This sheet transmits Revision 03 to Service Bulletin 190-22-0004.

AUTO FLIGHT - CAT IIIa AUTOLAND INSTALLATION

REVISION 03: This revision has been issued to include the aircraft serial numbers 19000590, 19000592, 19000600, 19000615 and 19000621 in the Service Bulletin effectivity and to replace Cable assy PN 171-06712-401 to PN 171-06712-403.

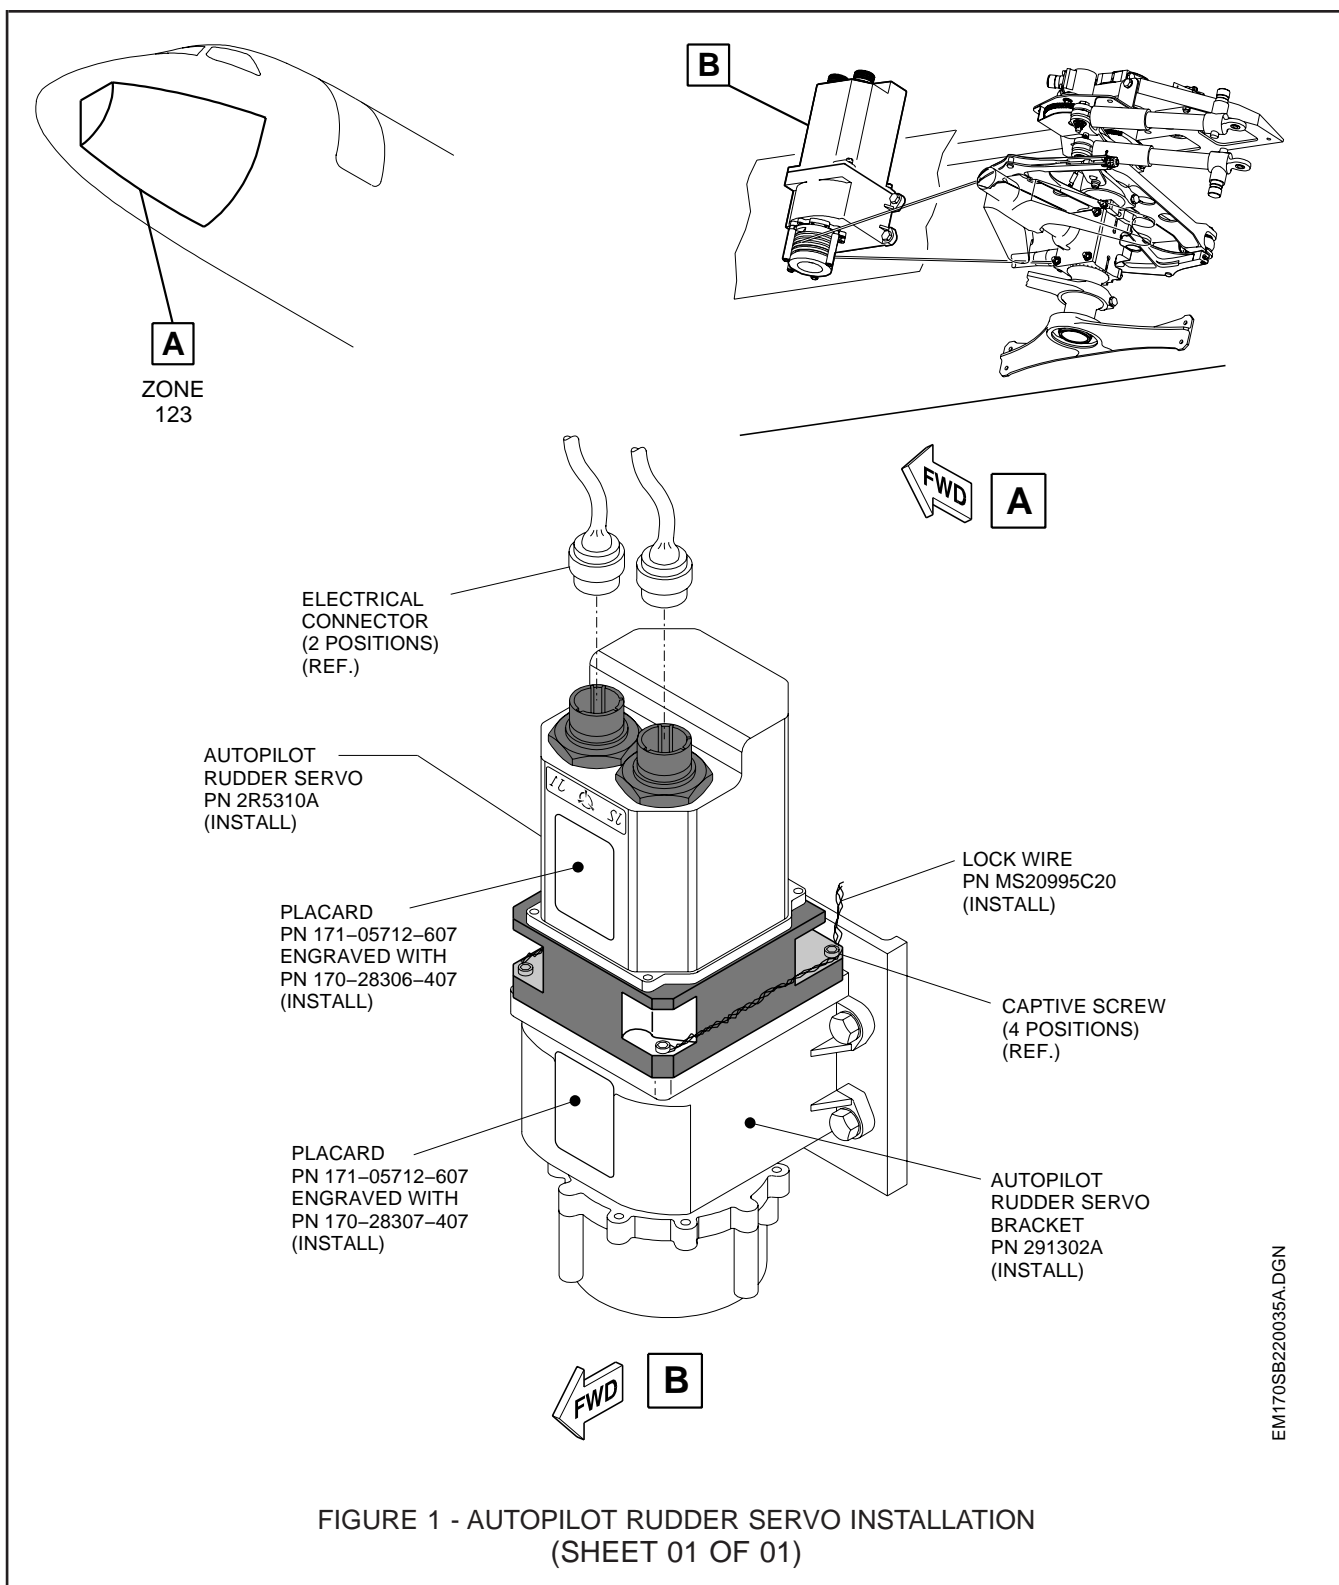
- (1) Install autopilot rudder servo bracket PN 291302A in conjunction with autopilot rudder servo PN 2R5310A in accordance with AMM TASK 22-11-06-400-802-A/400 - Autopilot Rudder-Servo Bracket - Installation. Refer to [Figure 1](#).

NOTE: To make the electrical connection, it is necessary to release the existing clamp which ties the electrical cable as a loop, connect the electrical connector (2 positions) to the autopilot rudder servo, and install clamp PN MS21919WDG6 in the place from which the used clamp was removed.

- (2) Install autopilot rudder cable PN 171-06712-403 and PN 170-03487-401 in accordance with AMM TASK 22-11-09-400-801-A/400 - Autopilot Rudder Cable - Installation.
- (3) Install placard PN 171-05712-607 on autopilot rudder servo bracket (identified with PN 170-28307-407) in accordance with AMM TASK 20-10-09-400-801-A/400 - Placards and Markings - Installation. Refer to [Figure 1](#).
- (4) Install placard PN 171-05712-607 on autopilot rudder servo (identified with PN 170-28306-407) in accordance with AMM TASK 20-10-09-400-801-A/400 - Placards and Markings - Installation. Refer to [Figure 1](#).
